WCAP-16530-NP-A

# **Evaluation of Post-Accident Chemical Effects in Containment Sump Fluids to Support GSI-191**

SUBJECT: FINAL SAFETY EVALUATION FOR PRESSURIZED WATER  
REACTOR OWNERS GROUP (PWROG) TOPICAL REPORT (TR)  
WCAP-16530-NP, "EVALUATION OF POST-ACCIDENT CHEMICAL EFFECTS  
IN CONTAINMENT SUMP FLUIDS TO SUPPORT GSI-191" (TAC NO. MD1119)

Revised Figure 5.2-16: Volume of Precipitate Observed in the Settling Cones

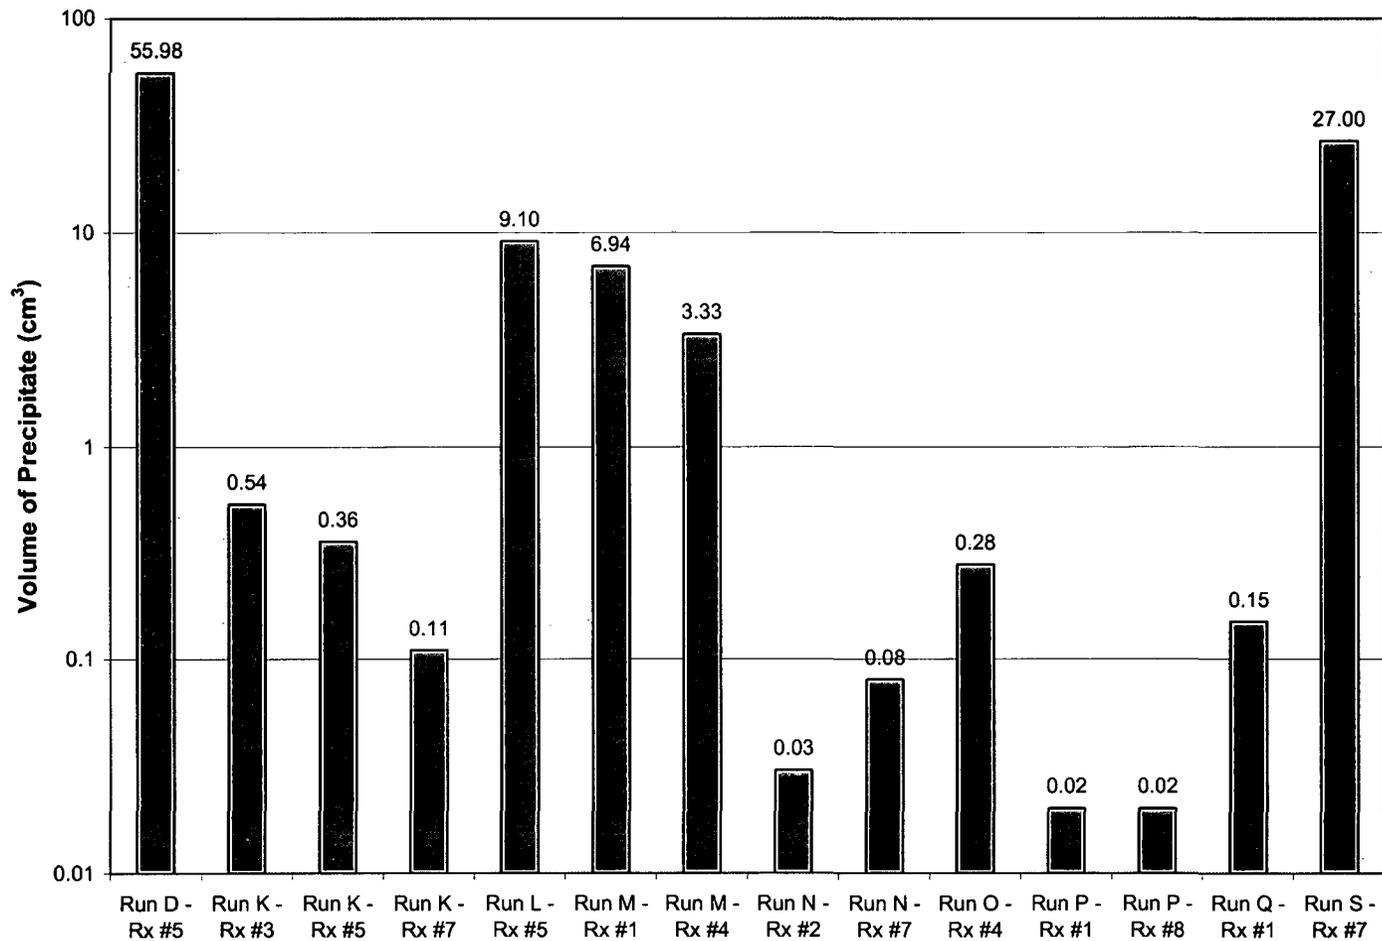
Discussion of precipitate formation on Page 78 states that measurable quantities of precipitates were formed in 25 experiments and the volume of precipitate formed for these cases is shown in Figure 5.2-16. This figure identifies the volume of precipitate observed for 14 run/reaction vessel designations. Later in the discussion, the TR indicates that Table 5.2-4 lists the experiments (13 of 60 experiments) where measurable precipitation occurred. Some of the run/reactor identities in Figure 5.2-16 (e.g., P1, P8, Q1) do not match with the identities in Table 5.2-4 (e.g., K2, K4, N2). Please clarify the discrepancy in the

number of experiments with measurable precipitation and test run identifications between Table 5.2-4 and Figure 5.2-16. For all experiments with measurable precipitate, please provide a table showing:

The discussion refers to 25 experiments in which precipitates formed which is a larger number than in Figure 5.2-16 or Table 5.2-4. The 25 value included runs that were rejected for experimental difficulties. The correct value is 17.

A corrected Figure 5.2-16 is shown below. The original figure included Run M7, a bad run, which has been eliminated. Run N2 was mislabeled as N5, which has also been corrected. The original figure also included only precipitates that formed by cooling from 265 °F. Four runs have been added (D5, P1, P8, and Q1) where precipitates formed upon cooling from 190 °F, even though these runs were not included in the precipitation test matrix. This figure does not include the 3 precipitates that formed by mixing different solutions, since different volumes of solution were involved than for the cooling tests.
